Competition Bulletin

no. 81-2

MODELS: 1981 SUPER-MOD

Subject: Modifying 1981 Super-Mod to
1982 Formula Specifications

DRIVE CLUTCH

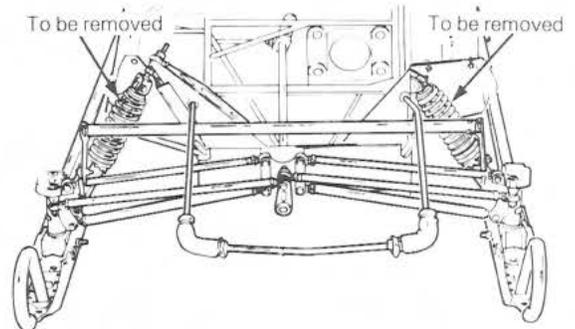
The drive clutch must be changed to a type A-1.

P/N 860 417 400 (3)

FRONT SUSPENSION

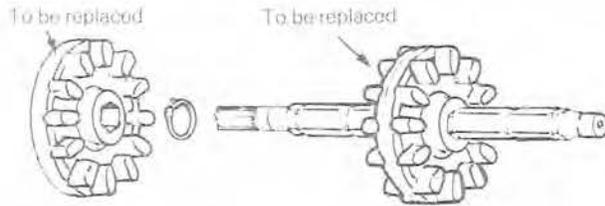
To reduce the height of the front end, it is suggested that the front springs and dampers be replaced. This will lower the front end by 1/2" and increase the aerodynamics.

NOTE: If springs and dampers are changed, refer to Owner's Manual for correct front end adjustment procedure.

P/N 414 481 500 - Damper (2)
P/N 505 036 800 - Spring R.H. (1)
P/N 505 036 900 - Spring L.H. (1)

REAR SUSPENSION

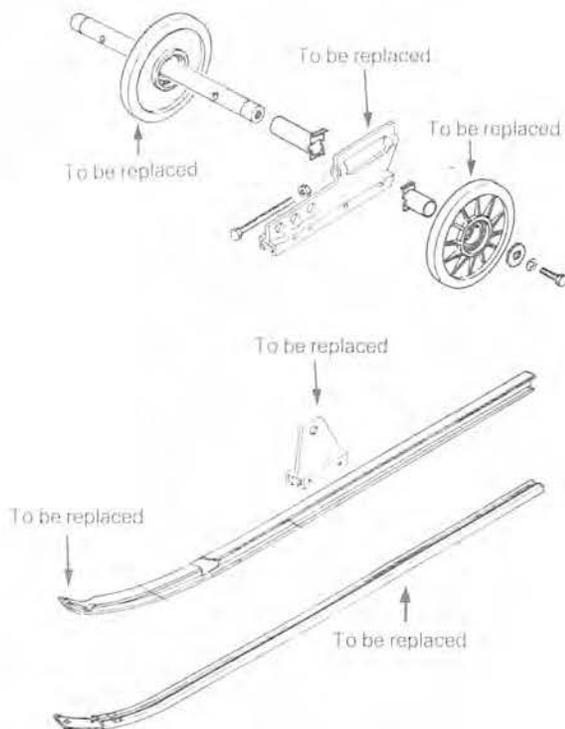
The modification of the rear suspension will make it more adjustable for different track conditions.

The runner is being replaced due to the angle not being as severe as the old one.

This gives the track more ground pressure at the front of the suspension.

P/N 503 069 800 – Runner (2)

P/N 560 305 900 – Slider (2)

P/N 503 069 900 – Arm support (2)

P/N 503 070 000 – Rear support (2)

P/N 503 070 100 – Inside rear idler (1)

P/N 503 070 200 – Outside rear idler (2)

Front arm support

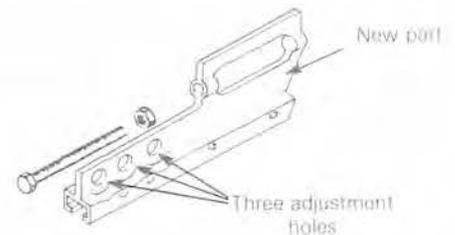
The slider has been changed to accommodate the new runner.

The front arm support has been changed due to the fact that the arm is now located one inch lower than before. The relocation works directly with the new runner.

Rear arm support

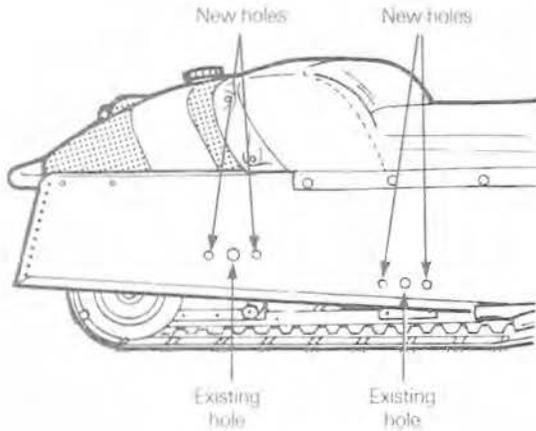
The new rear support now has three (3) position holes instead of one. This enables the driver to change the pivot point.

Front hole will give more transfer and more back end. Back hole will give less transfer and less back end.

○ **NOTE:** When installing the new arm supports, use the old runner as a template. Drill the holes using a no. 13 drill bit and install new spiral pins (P/N 372 009 200).

▼ **CAUTION:** The rear suspension modification must be done in conjunction with the frame modification.
